**STAFF RECOMMENDATION**  
**1100 Matthews Place**  
**August 20, 2014**

**Application:** Demolition—primary structure and outbuilding; New construction—infill and outbuilding

**Description of Project:** Application is to demolish an existing non-contributing primary structure and outbuilding, and to construct a new duplex infill and outbuilding.

SITE PLAN  
 NOT TO SCALE

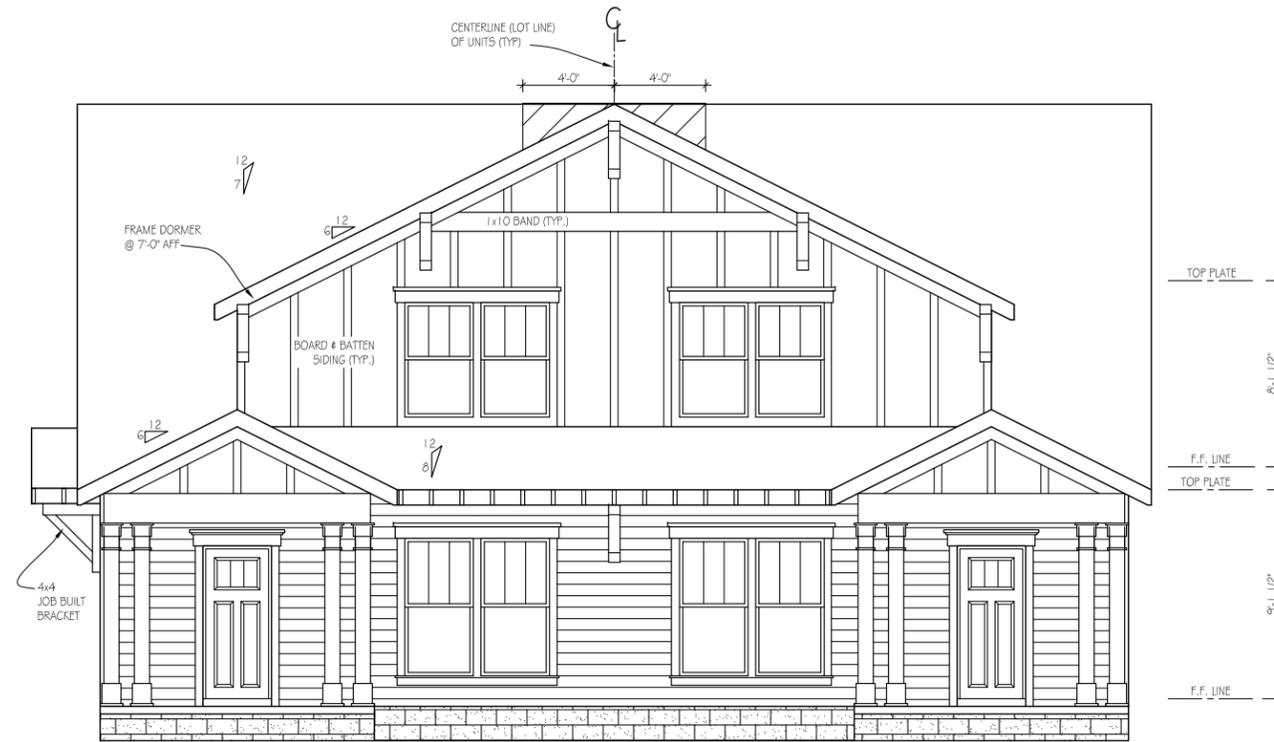
Orientation: The duplex is oriented so that the entries to both units face Matthews Place. The duplex units will have two separate entrances, both of equal prominence, each behind a partial-width front porch that is eight feet (8') deep. The site plan shows no pathways on the site, and staff asks that pathways be added from Matthews Place to the front entries of the two duplex units. There will be a recessed side entrance, with a simple overhang and no porch element, off of Sharpe Avenue. Staff finds that this side entrance clearly reads as a secondary entrance and is therefore appropriate.

Currently, there is an existing double-width curb cut off of Sharpe Avenue, about midway through the property (Figure 3). The applicant is proposing to relocate the

driveway and curb cut to the rear of the property in order to access the proposed two-car garage. The driveway includes an uncovered parking pad adjacent to the garage on the Sharpe Avenue side and another uncovered parking pad space behind the garage. Staff finds that the relocated driveway and parking area is appropriate because it is located at the rear of the site, because there is no alley along this site, and because most of the properties facing Sharpe Avenue have driveways off of Sharpe Avenue.

**Appurtenances & Utilities:** The location of the HVAC and other utilities was also not noted on the site plan. Staff asks that the HVAC units be located on the rear façade, or on the interior lot side façade beyond the midpoint of the house.

**FRONT ELEVATION**

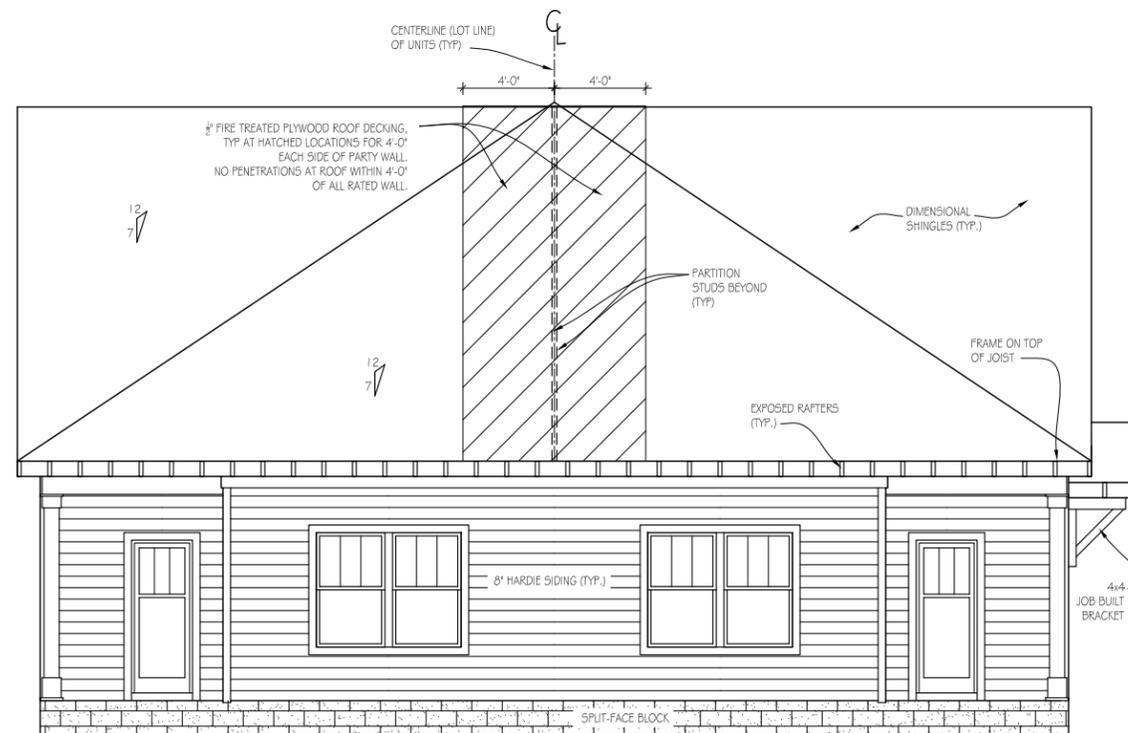
**Height & Scale:** The infill will be one-and-a-half stories. It will have an eave height of approximately ten feet (10') above grade, and a ridge height of approximately twenty-eight feet (28') above grade. Most of the surrounding structures on Matthews Place and Sharpe Avenue are non-contributing, so staff compared the height of the proposed infill to historic houses facing Chapel Avenue and Manchester Avenue. Staff finds that the proposed infill's height does meet the historic context of this area, where historic houses are predominantly one and one-and-a-half stories tall, with some scattered two-story structures, and where the historic houses range in height from nineteen feet to thirty feet (19'-30') tall. The foundation height is shown as approximately eighteen inches (18") high. Staff asks to verify in the field during construction that the finished floor height of the infill is consistent with the finished floor heights of neighboring houses.

Materials: The drawings indicate that the primary cladding material will be eight inch (8") Hardie board siding, and staff asks that the siding be smooth-face and have a maximum reveal of five inches (5"). Board and batten will be used as an accent material in the front dormer, the front porch gable fields, and the side gable fields. The trim will be wood or cement fiberboard. The roof will be asphalt dimensional shingles, and staff asks to approve the shingle color. The foundation will be split face concrete block. The materials for the windows and doors were not specified, and staff asks to approve all window and door specifications. The front porch columns will be wood. The material for the front porch floors was not specified, and staff asks to approve the floor material. With the aforementioned staff approvals, staff finds that the known materials meet Section II.B.1.d. of the *Eastwood Neighborhood Conservation Zoning Overlay: Handbook and Design*

Roof form: The infill's primary roof form will be a side gable with a slope of 7/12. At the rear, there will be an extension with a hipped 7/12 hipped roof. The front façade features a large central gabled dormer with a slope of 6/12. The dormer is inset two feet (2') from the wall below, and staff asks that the dormer be set down from the ridge of the infill by at least six inches (6'). The gabled front porch roofs have a 6/12 slope. Connecting the porch roofs is an awning that has an 8/12 pitch. There are no posts or porch floor to this awning. Staff recommends removal of the center awning as the form is not similar to the historic context. Typically awnings only covered windows, doors or porches. With the condition that the front dormer be located at least six inches (6") below the duplex's ridge and the front awning be removed, staff finds that the infill's roof forms meet Section II.B.1.e. of the *Eastwood Neighborhood Conservation Zoning Overlay: Handbook and Design*.

**FRONT ELEVATION**

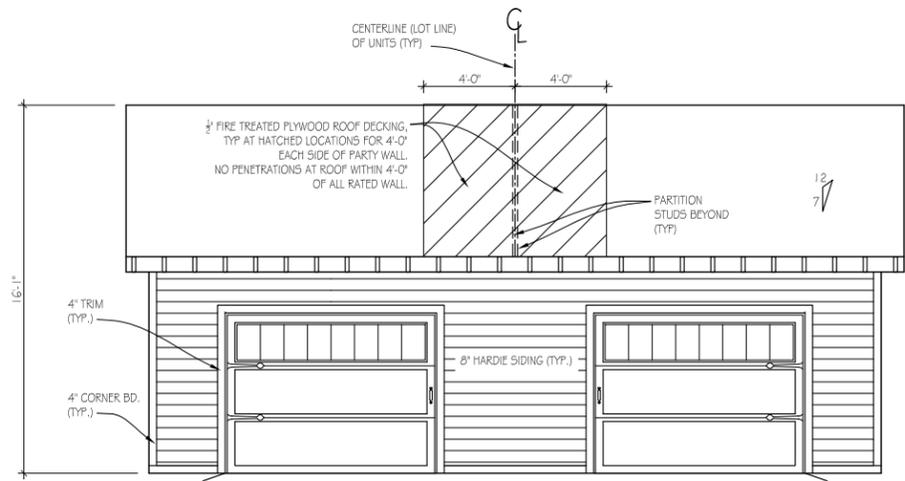
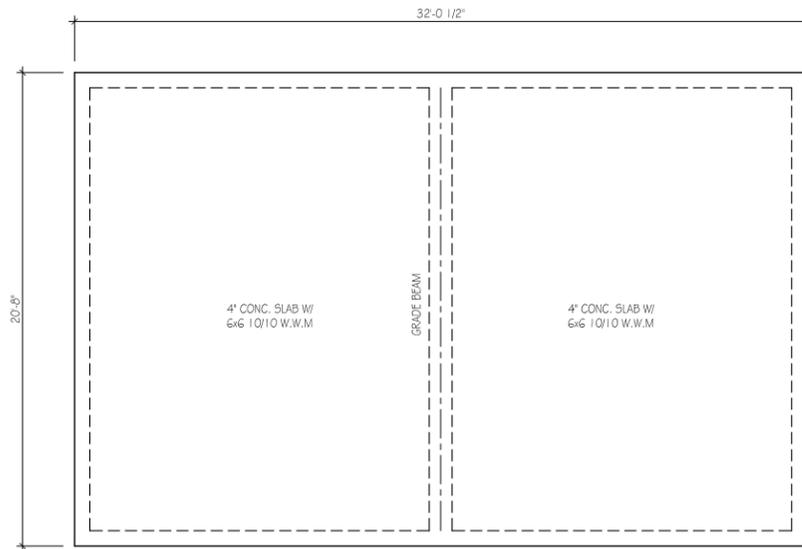
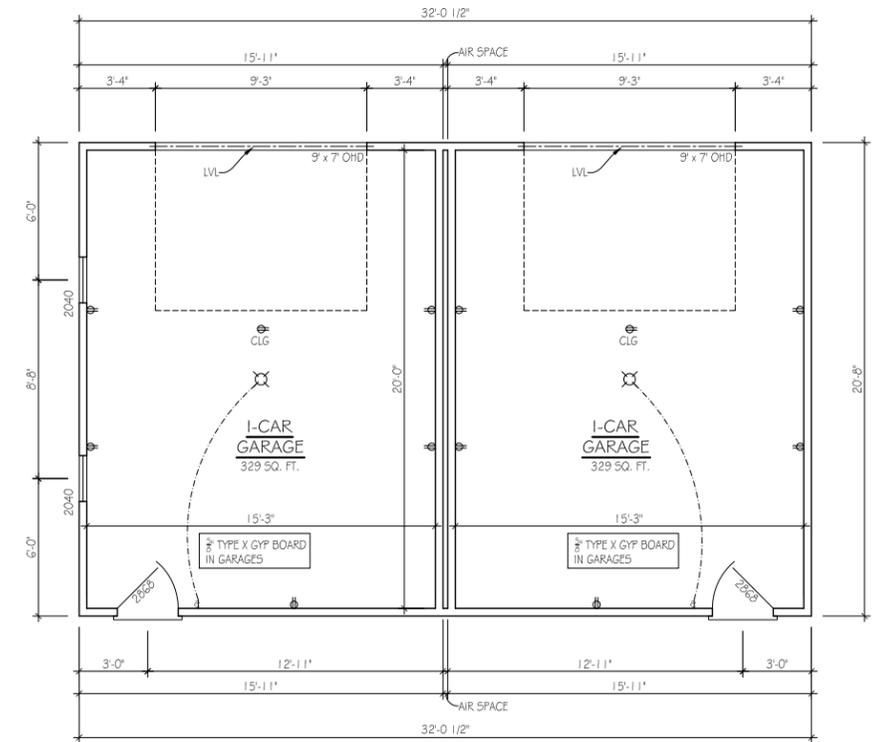
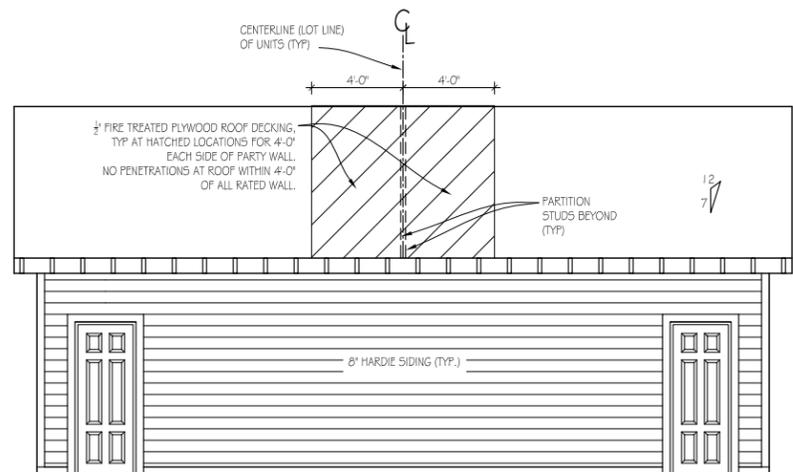
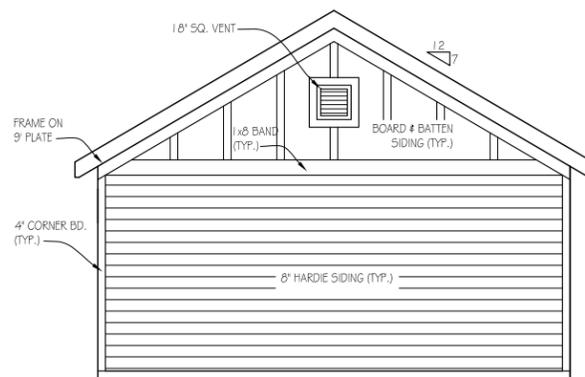
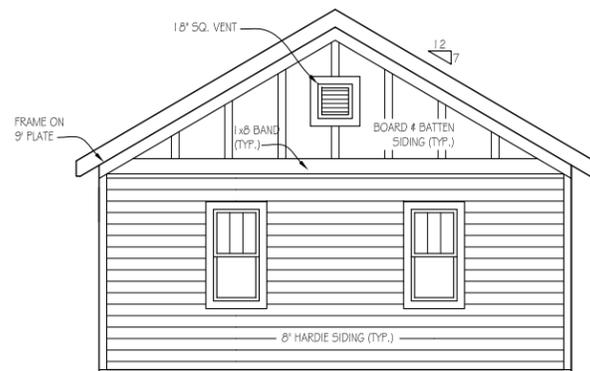
**Outbuildings:** The applicant is proposing a one-story, two-bay garage. The garage will be accessed via a new curb cut off of Sharpe Avenue, towards the rear of the lot. It will be oriented so that the garage doors face the rear of the lot, not Sharpe Avenue. The garage will meet all base zoning setbacks, as it will be twenty-five feet (25') from the rear property line, seventeen feet, one inch (17'1") from the Sharpe Avenue side property line, and twelve feet, one inch (12'1") from the interior/north side property line.

The garage will be thirty-two feet, one inch (32'1") wide and twenty feet, eight inches (20'8") deep, or six hundred and sixty-three square feet (663 sq.ft.). The garage will

have an eave height of approximately nine feet (9') and a ridge height of approximately sixteen feet (16'). The roof will be gabled with a slope of 7/12. The proposed materials will be similar to those proposed for the infill. Staff notes that the lap siding shall have a maximum reveal of five inches (5"), not eight inches (8") as the drawings indicate.

With the condition that the lap siding be smooth face and have a maximum reveal of five inches (5"), staff finds that the proposed outbuilding meets section II.B.1.h. of the *Eastwood Neighborhood Conservation Zoning Overlay: Handbook and Design*.
